PRODUCT CHANGE NOTICE

1. TITLE Packaging, 14 lead Flatpack Carrier	2. DOCUMENT NUMBER FV5-C-12-005
3. DATE August 27, 2012

4. MANUFACTURER AND ADDRESS International Rectifier 205 Crawford Street Leominster, MA 01453	5. MANUFACTURER PART NUMBER See below for IR Part Numbers
6. BASE PART NA	
7. NATIONAL STOCK NUMBER (NSN) NA

Figure 1 - 14 Lead Flatpack Carrier

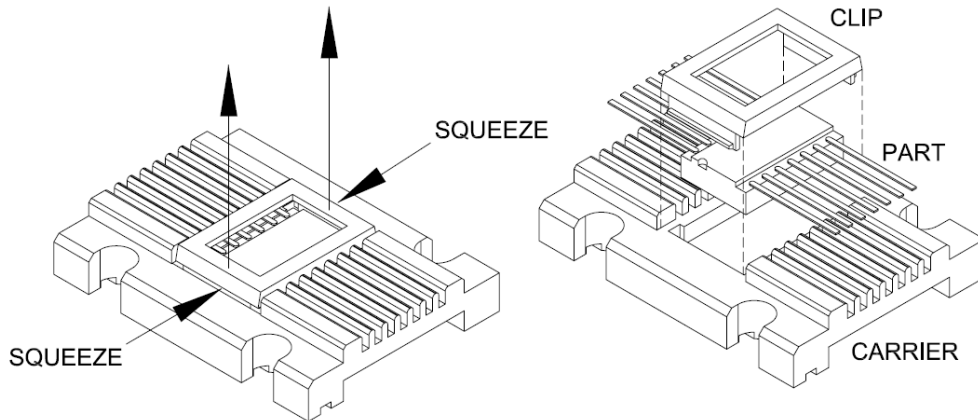
This GIDEP PCN is to announce a change in the delivery packaging method of the RIC7113A4 product type. Packaging will be changed from the standard part tray to individual 14 lead flatpack carriers (see figure 1 below for detail). The carriers will help protect the leads from damage through delivery and storage.

To remove the flatpack part from the carrier, disengage the clip (top side frame) from the carrier by squeezing in the sides. The clip can then be removed to free the part.
